## **CALGARY SUBDIVISION**

The preliminary plat illustrates the proposed 47-lot, 17.7± acre subdivision which is located on the West side of Leroy Stevens Road, 200'± North of Pine West Avenue. The site is within the Planning Jurisdiction and the City Fire Jurisdiction and the applicant states that the subdivision is served by city water and sewer.

APPLICATION NUMBER 13 DATE October 20, 2016

# DETAIL SITE PLAN

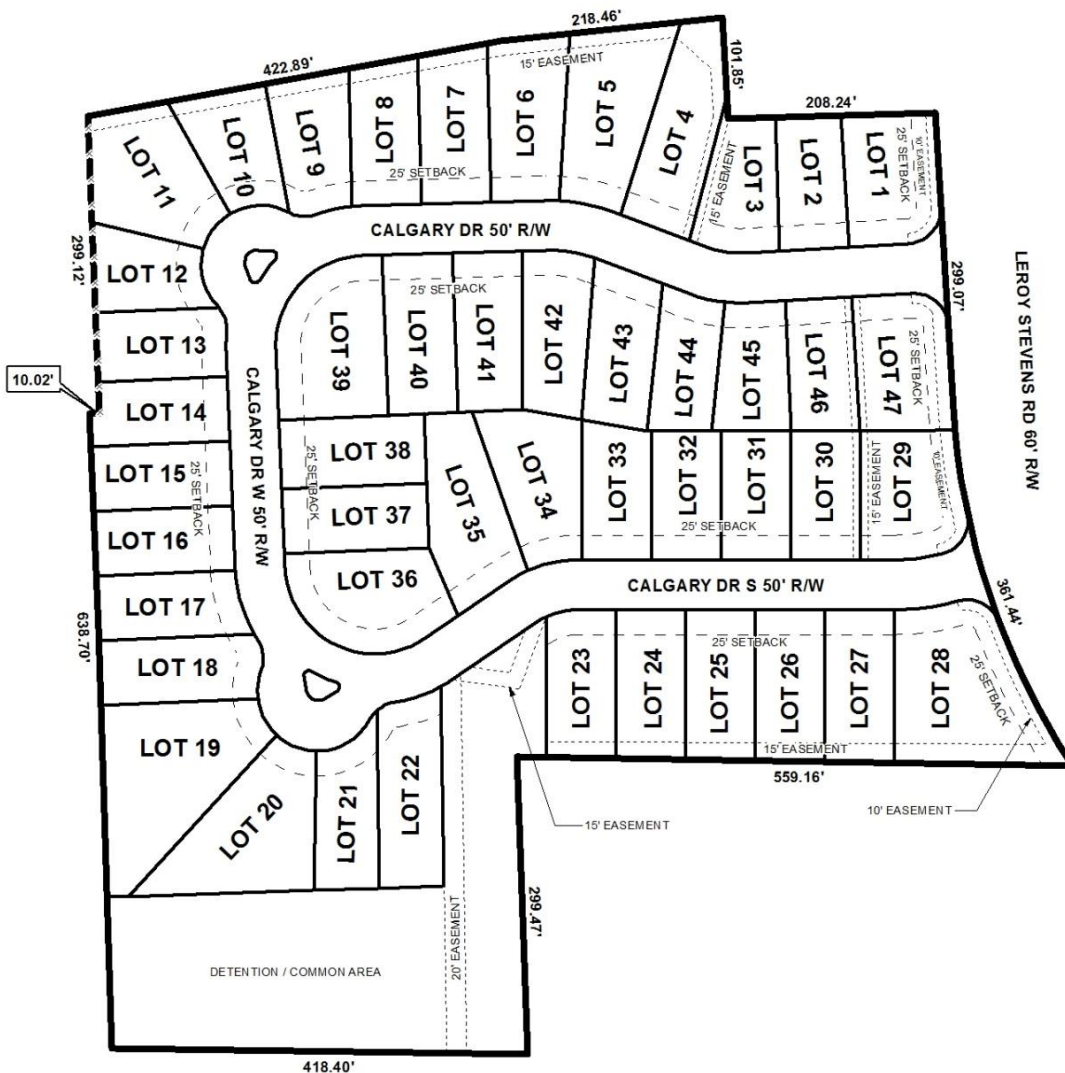
The proposed subdivision fronts Leroy Stevens Road, a minor street with a compliant right-of-way diameter. The right-of-way width of all proposed streets within the subdivision is 50', compliant with Section V.B.14. of the Subdivision Regulations.

Per Fire Department previous comments regarding the required number of access points to a site with 30 or more dwelling units, a second access point has been illustrated.

The 25' minimum building setback line and lot size information are depicted on the preliminary plat and, if approved, should be retained on the Final Plat.

The current proposal depicts several lots with frontage onto streets internal to the development and Leroy Stevens Road. Normally, Section V.D.8. would require a 10' wide buffer park strip, however, Staff recommends a waiver of the 10' wide buffer park strip of Section V.D.8. of the Subdivision Regulations along Leroy Stevens Road, if approved.

As a means of access management, a note should be placed on the Final Plat stating that all lots are denied direct access to Leroy Stevens Road, and that all proposed lots be limited to 1 curb-cut each to streets within the subdivision, with the size, design and location to be approved by Mobile County Engineering and conform to AASHTO standards.

The overall development will consist of 3 common areas, one of which will be for storm water detention. If approved, the Final Plat should include a note stating that all common and detention areas shall be maintained by the property owners.

The plat also depicts the presence of easements throughout the site and, if approved, a note should be placed on the Final Plat stating that no permanent structures can be placed or erected within any easement, with the exception of the proposed 10' fence easement along Leroy Stevens Road.

- 1) Retention of 50' right-of-way width of all proposed streets within the subdivision;
- 2) Retention of two access points to the site;
- 3) Retention of 25' minimum building setback line;

- 4) Retention of lot information in both square feet and acres;
- 5) Placement of a note stating that all proposed streets must be built and paved in asphalt to Mobile County Engineering standards and be accepted by Mobile County

- 6) Placement of a note should be placed on the Final Plat stating that all lots are denied direct access to Leroy Stevens Road, and that all lots are limited to 1 curb-cut each to streets within the subdivision, with the size, design and location to be approved by Mobile County Engineering and conform to AASHTO standards;

- 7) Placement of a note stating that all common and detention areas shall be maintained by the property owners;
- 8) Placement of a note stating that no permanent structures can be placed or erected within any easement, with the exception of the fence easement;
